CITY OF SOMERVILLE, MASSACHUSETTS
OFFICE OF STRATEGIC PLANNING & COMMUNITY DEVELOPMENT
JOSEPH A. CURTATONE
MAYOR

HISTORIC PRESERVATION COMMISSION

ALTERATION TO A HISTORIC PROPERTY STAFF REPORT

Site: 222 Morrison Avenue c.1873 William Shedd House
Case: HPC 2014.012 Morrison Avenue Local Historic District

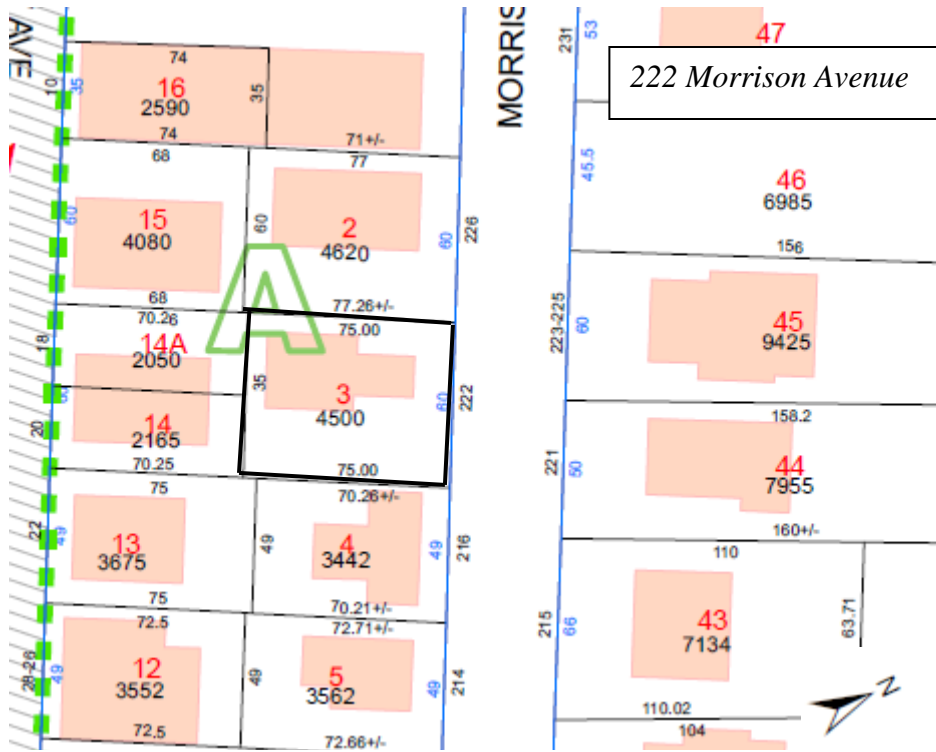
The porch will essentially be repaired, retaining the porch posts and other historic details. The proposed alteration would add handrails that are of a design consistent with the porch railings, ~~turned~~ plain simple balusters, and newel posts of other designated historic properties. A second rail will be added 7" above the one set at historic height. The second set of stairs descending into the backyard will be of the same design. This set of stairs is probably not original to the house. That section of porch railing was replaced with something else by the mid-1980s. The proposed skirt will be simple boards as can be seen on some of the designated properties shown below.

1. The new railings and balusters shall *exactly match those on the front of 45 Vinal Avenue in construction, size, shape, proportion, detail and material.*
2. The 6" newel posts shall be detailed to match the existing historic porch posts.
